December 09, 2022 City of Albuquerque Building and Safety 600 2nd St NW, Albuquerque, NM 87102

RE: DRB Project Number: 2021-006261

I am in receipt of comments provided on 12/06/2022 and have provided the following revisions, responses to those comments:

Project: GRIEGOS FARMS Phase: SD

SITE PLAN- REFUSE PLAN

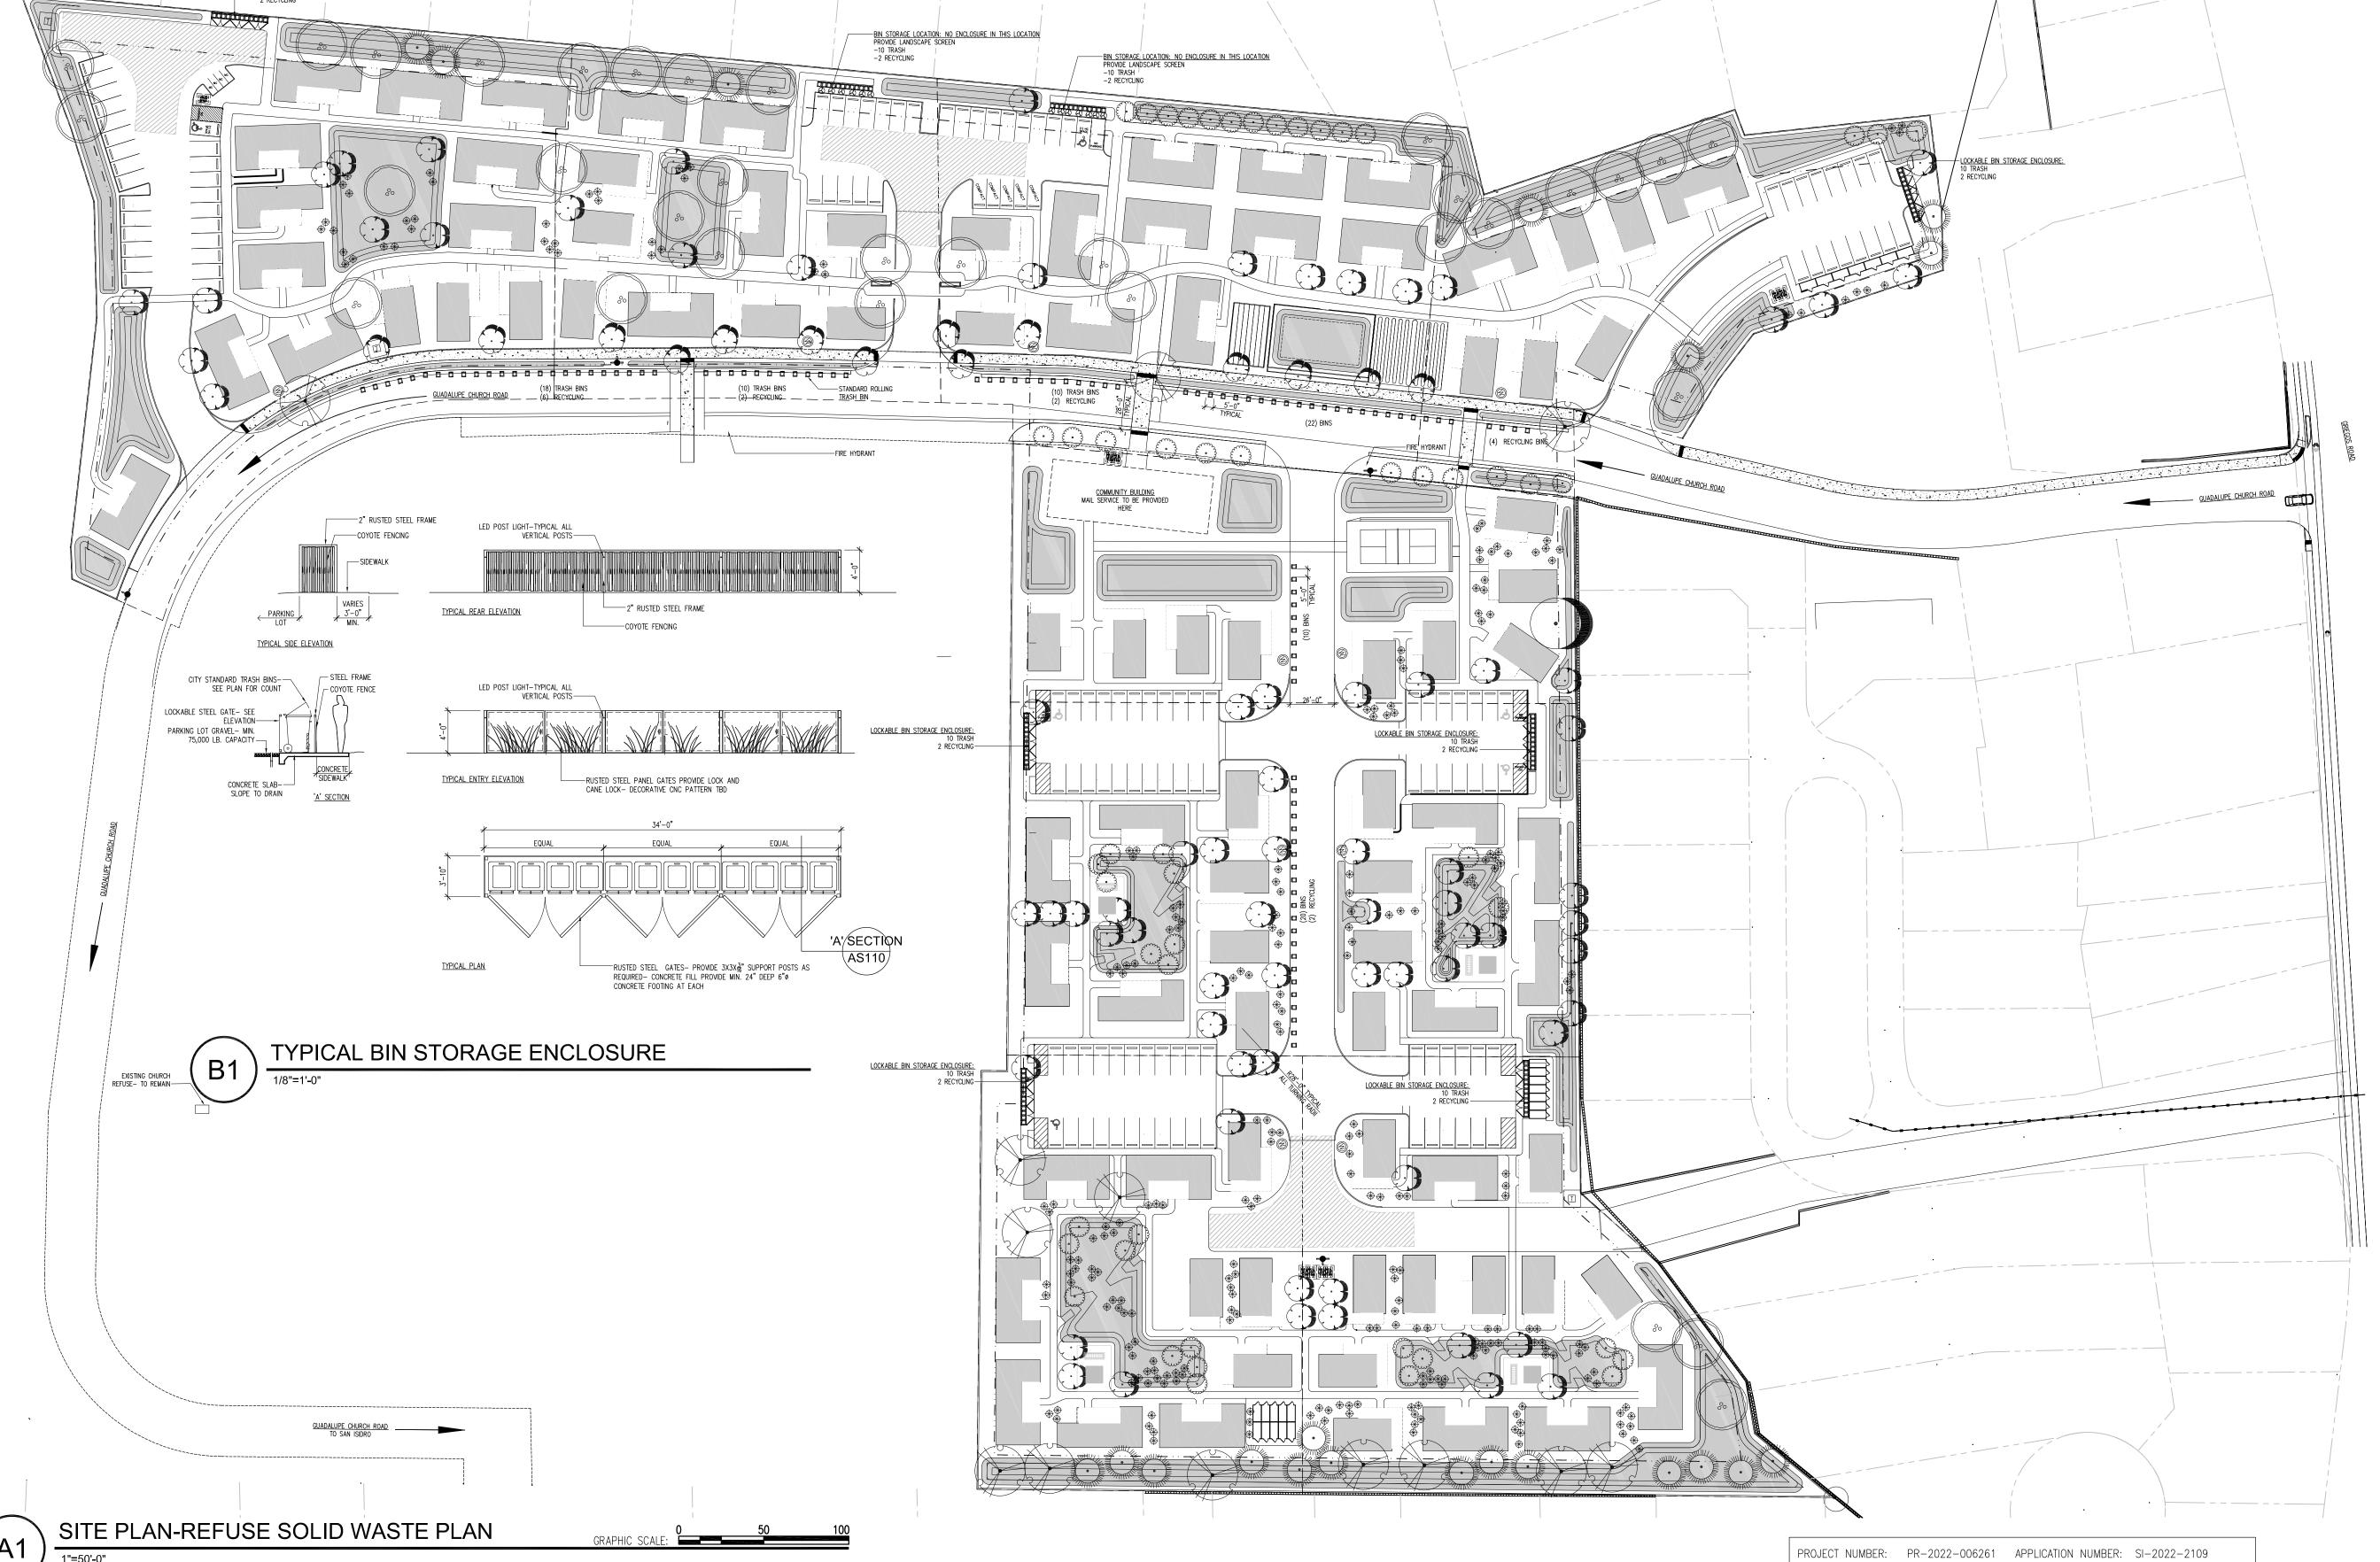
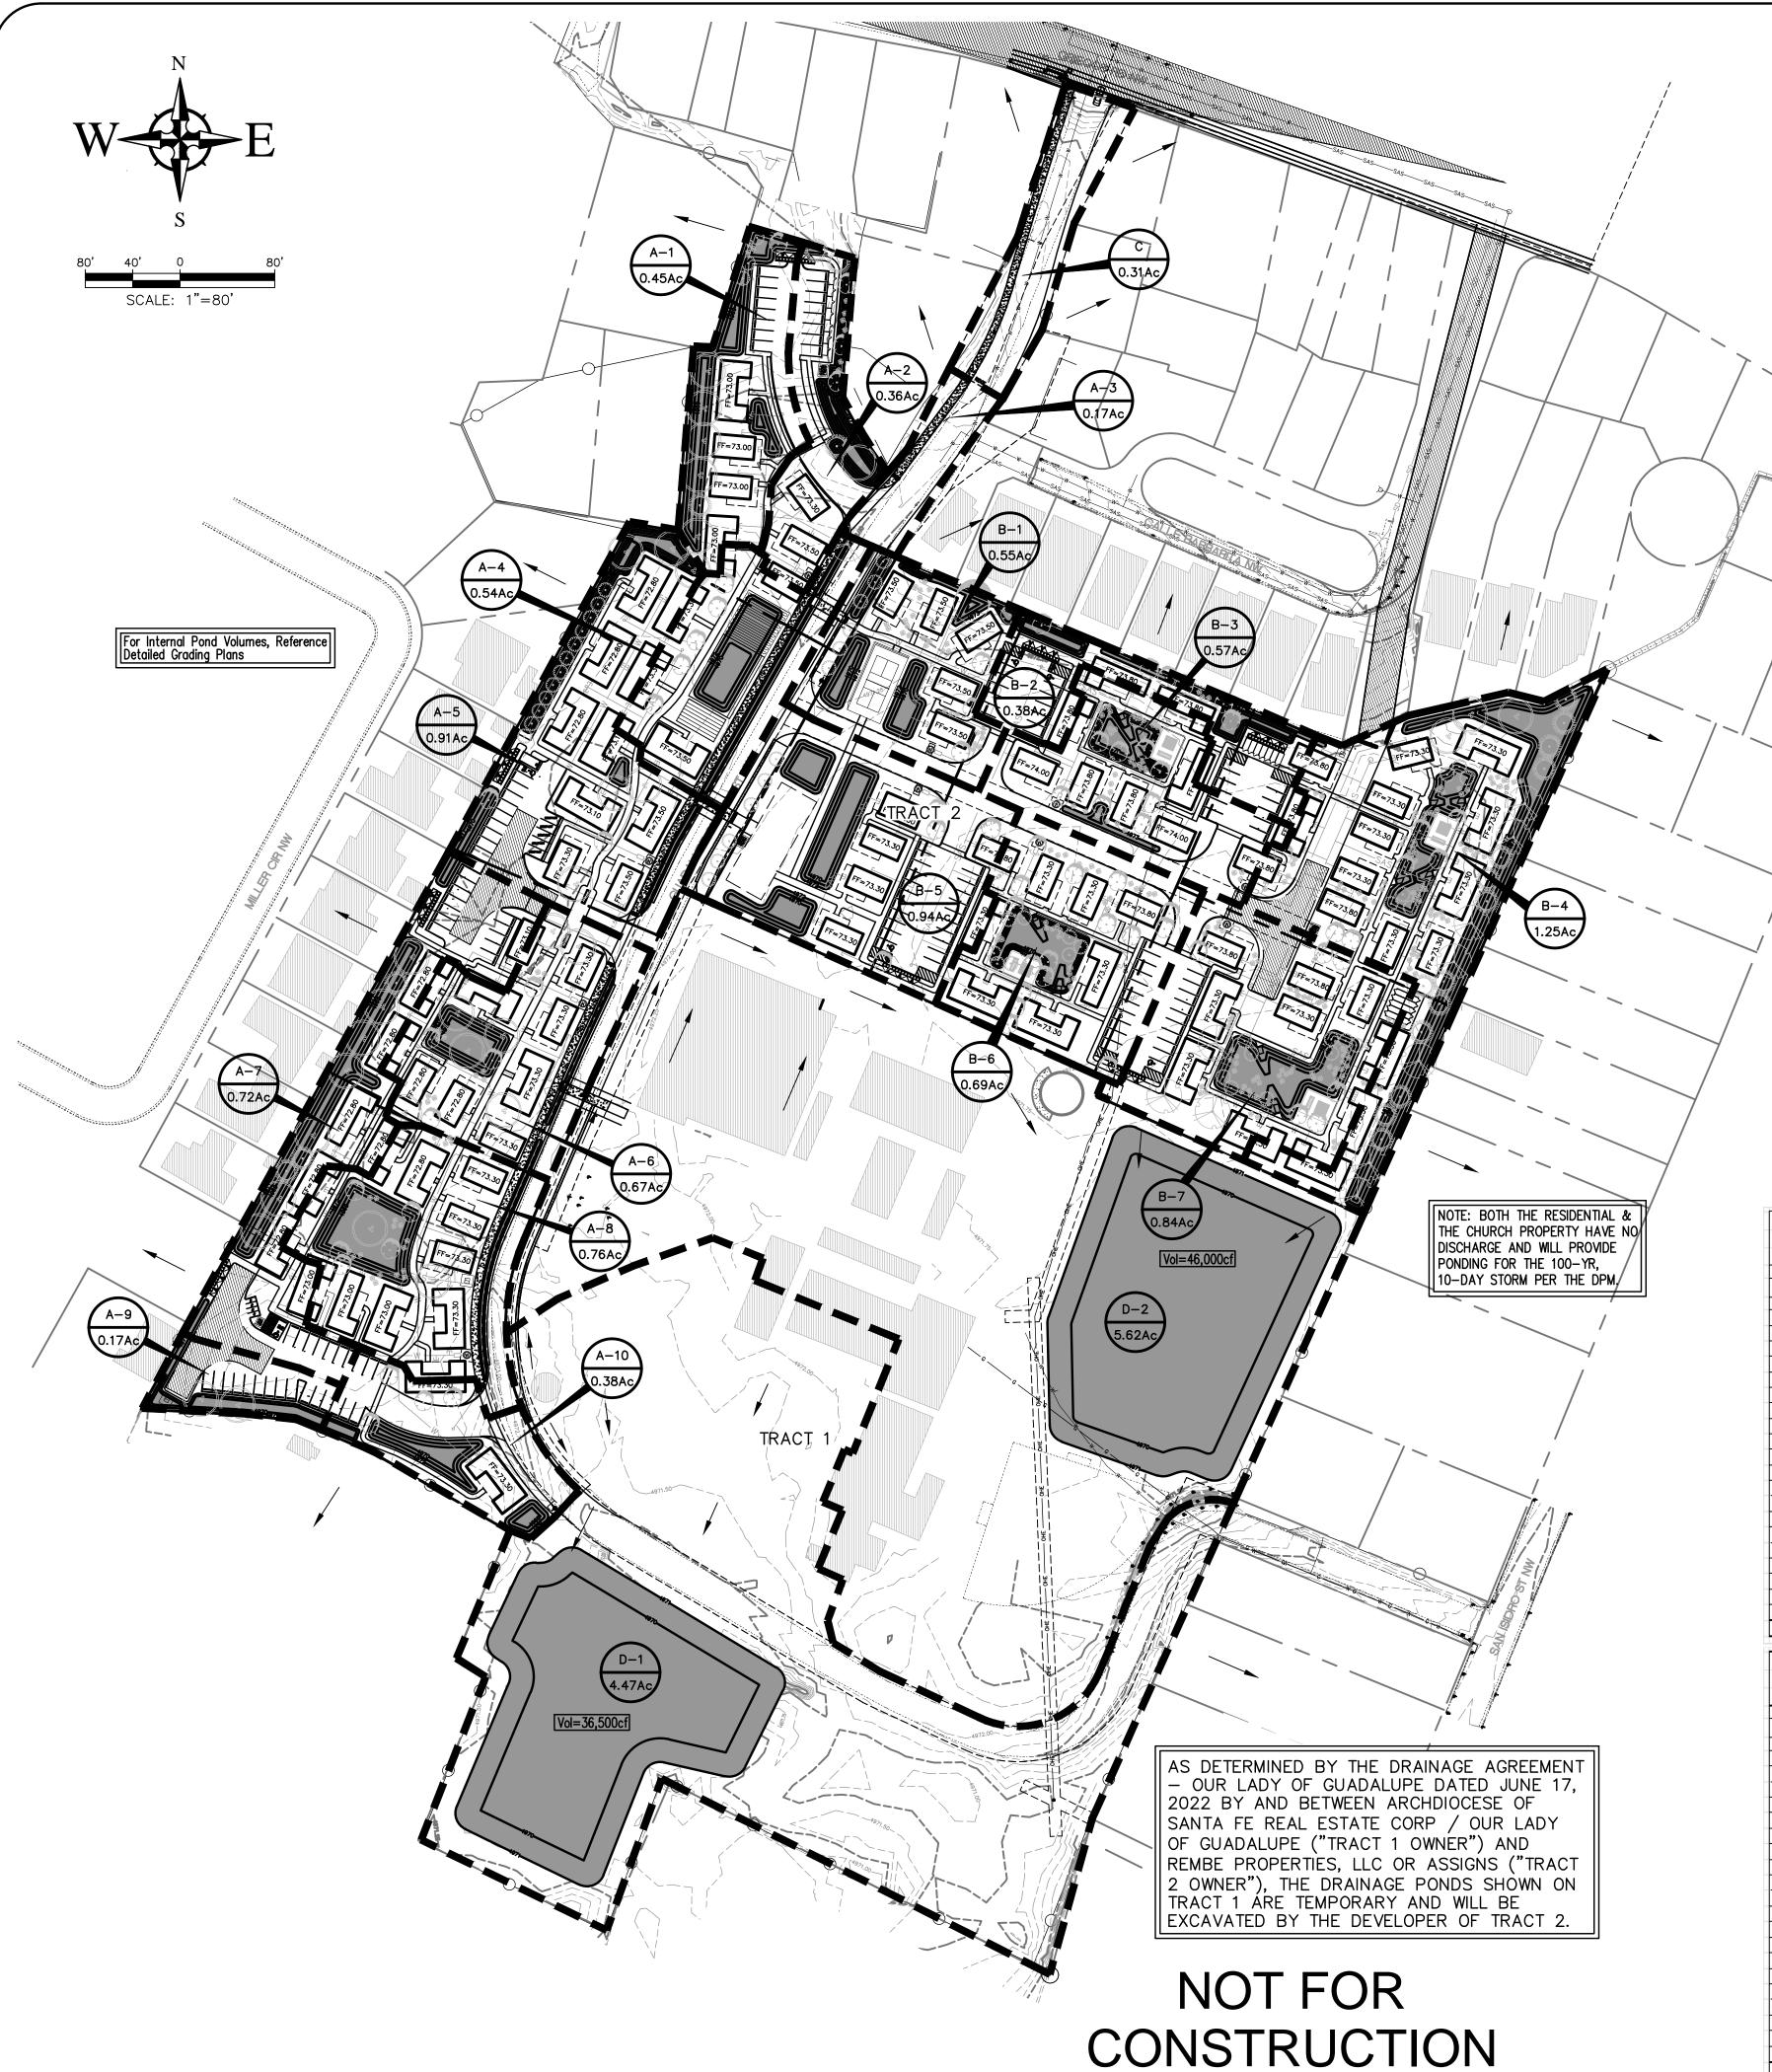
3. Did you obtain Fire Marshal approval and Solid Waste Approval for the plans.

Response: Both an approved Fire one, and Solid waste sheets, F1 and AS110 respectively, have been included in the application packet for your review. See pages 83 and 84 of 159.

Approved for access by the Solid Waste Department for 90 trash carts and 16 recycle carts.

DRAINAGE MANAGEMENT PLAN

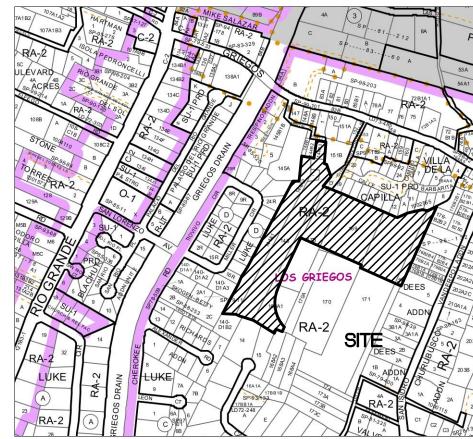
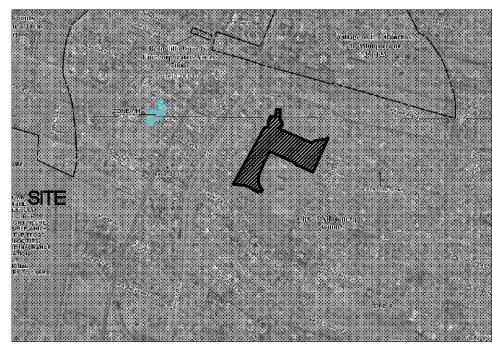
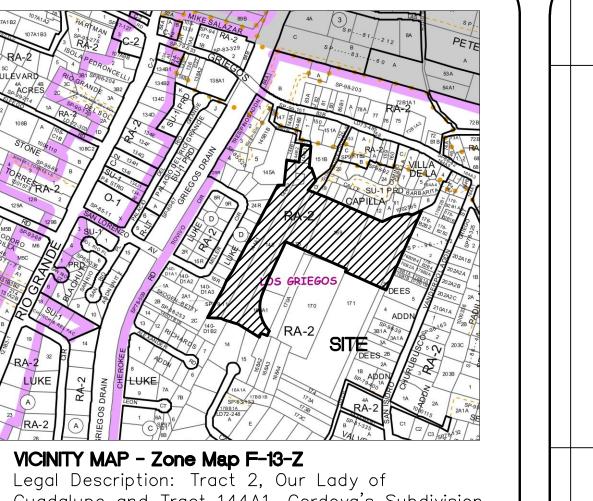
7. Confirm how the Preliminary Plat is reflecting the Bulk Land Plat note related to drainage.

Response: A note has been added to the Drainage Management Plan sheet C-206.
